Re: Taxiway Improvements  
Watertown Regional Airport  
Watertown, South Dakota  
AIP #3-46-0058-047/048-2025  
Helms #A-9070

**ADDENDUM NUMBER 2**

CONSTRUCTION SAFETY PHASING  
PLAN LAYOUT (PHASE III)

TAXIWAY IMPROVEMENTS  
WATERTOWN REGIONAL AIRPORT  
WATERTOWN, SOUTH DAKOTA

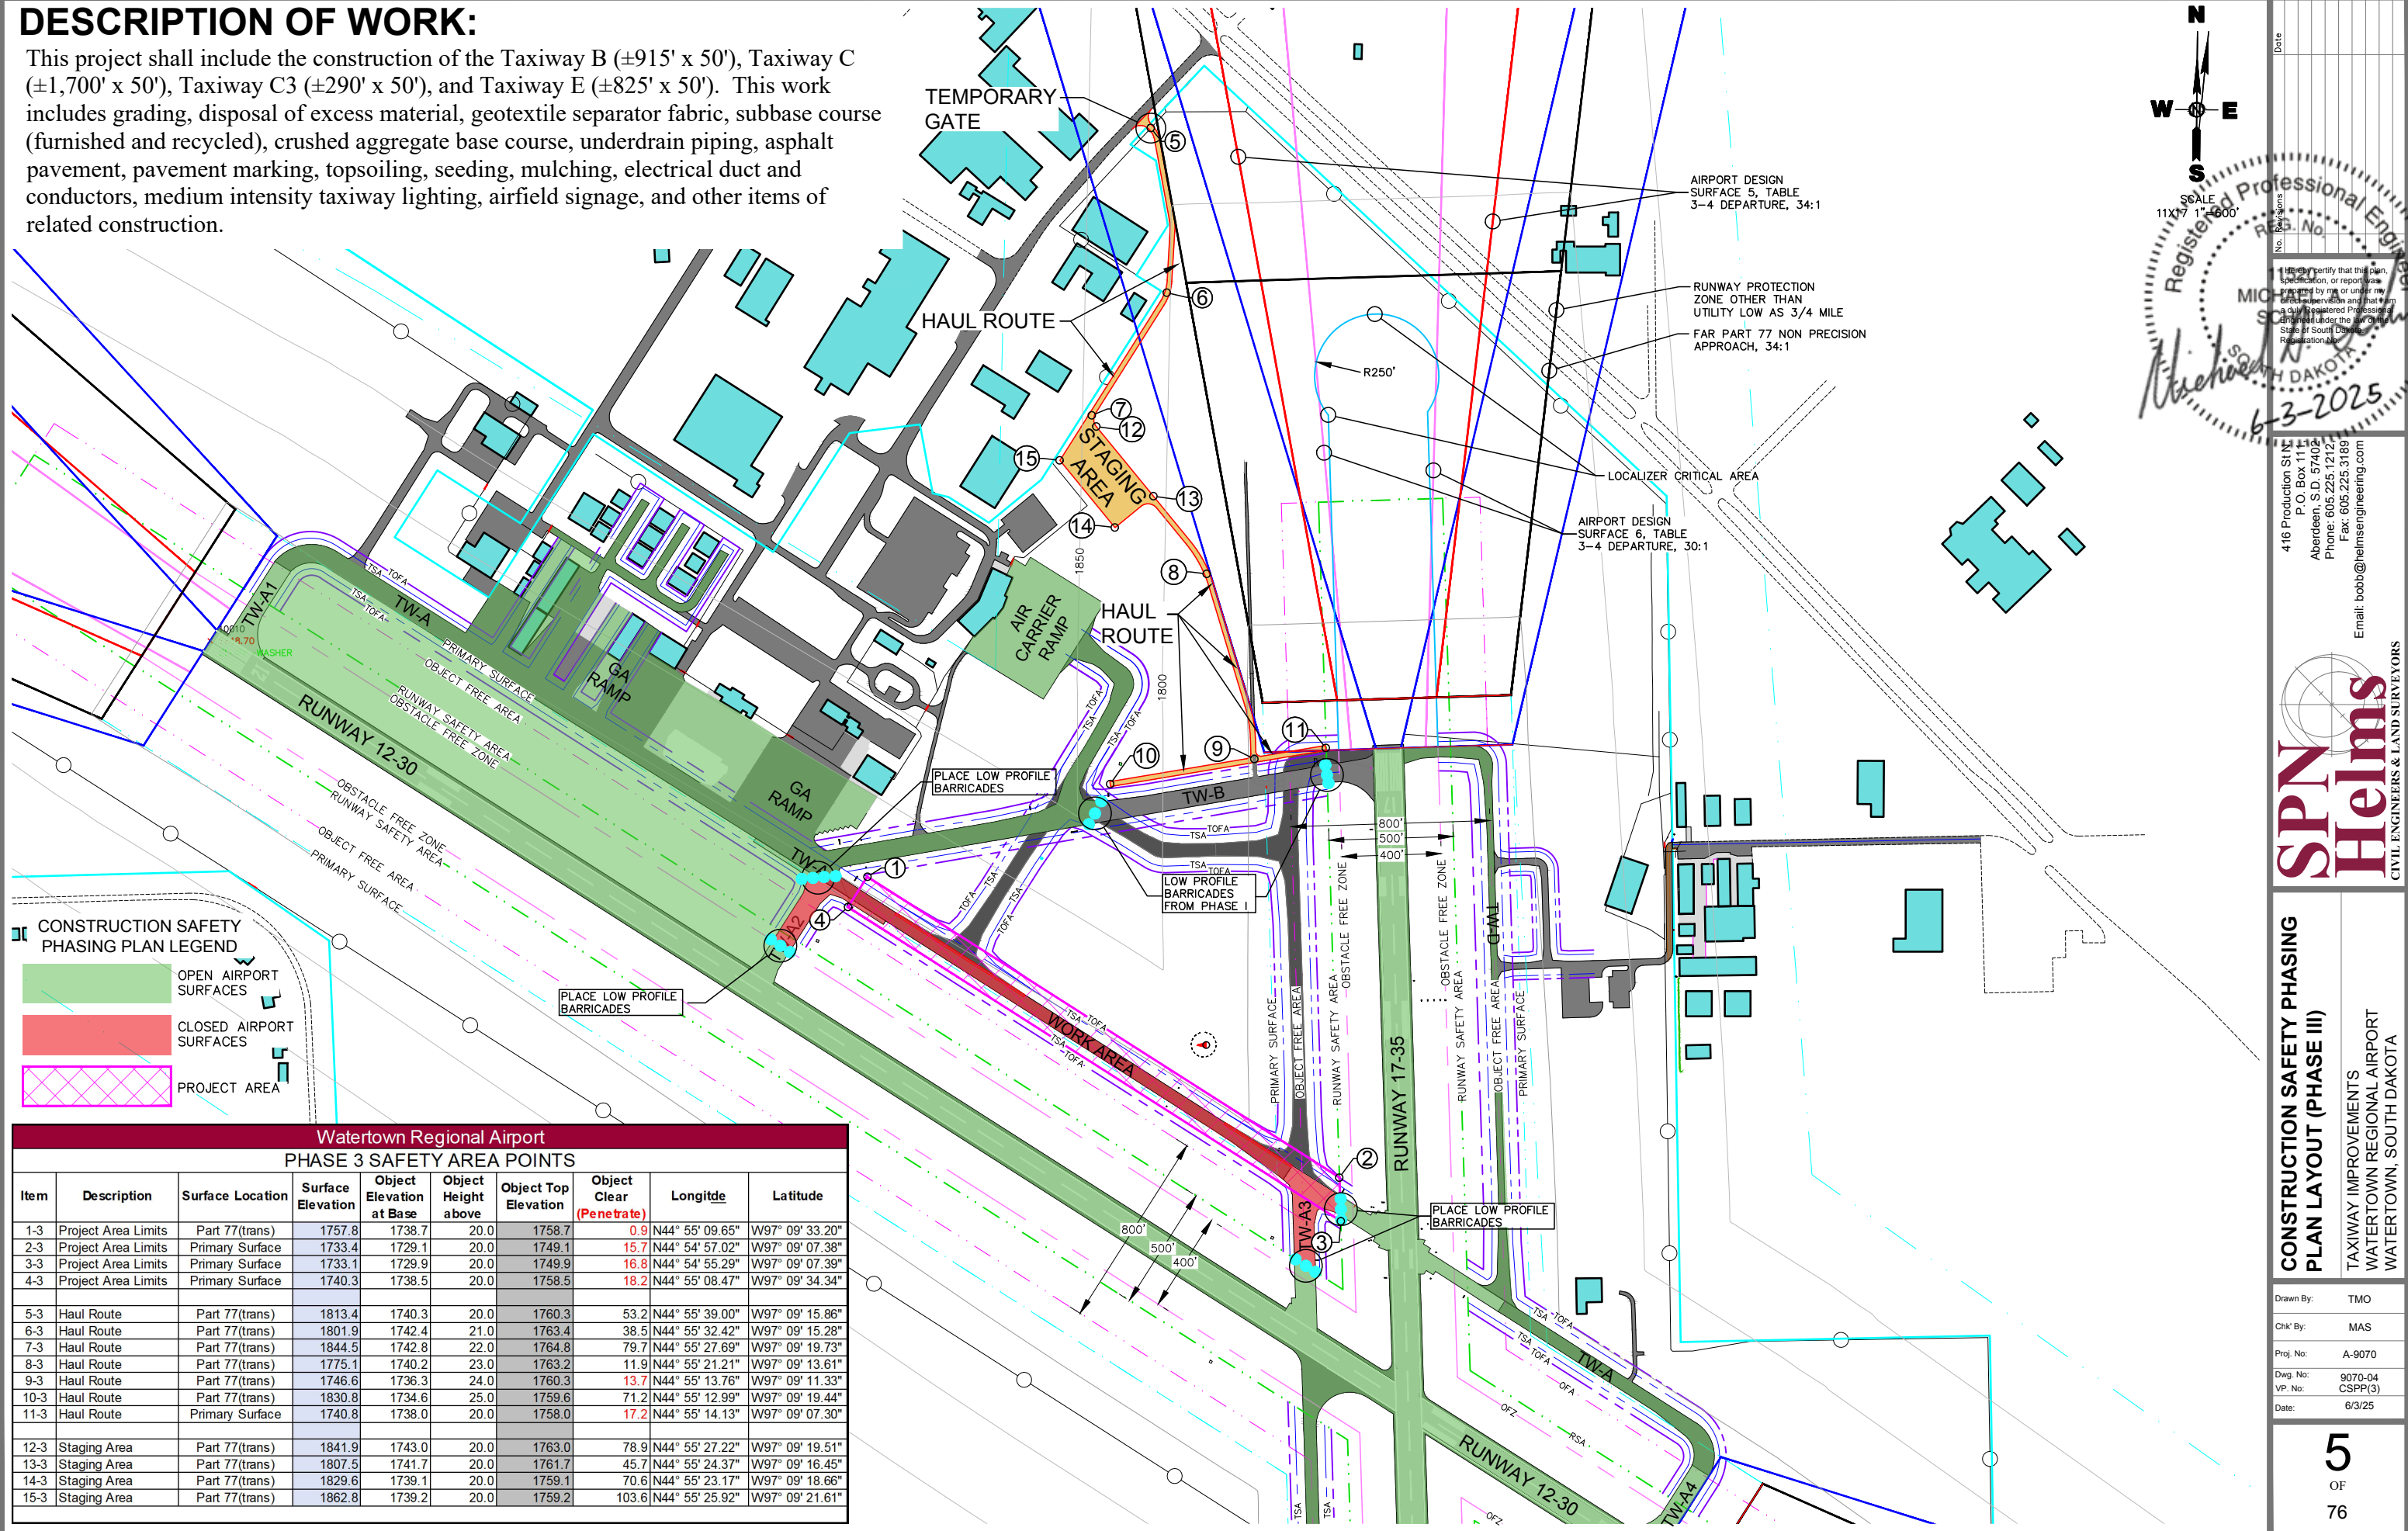
**1. Construction Safety Phasing Plan Layout (Phase III), Sheet 5, delete in its entirety and replace with the attached sheet.**

Adjustments to the low profile barricades and closure of Taxiway A2 to allow for a new sign at Taxiway A/A2.
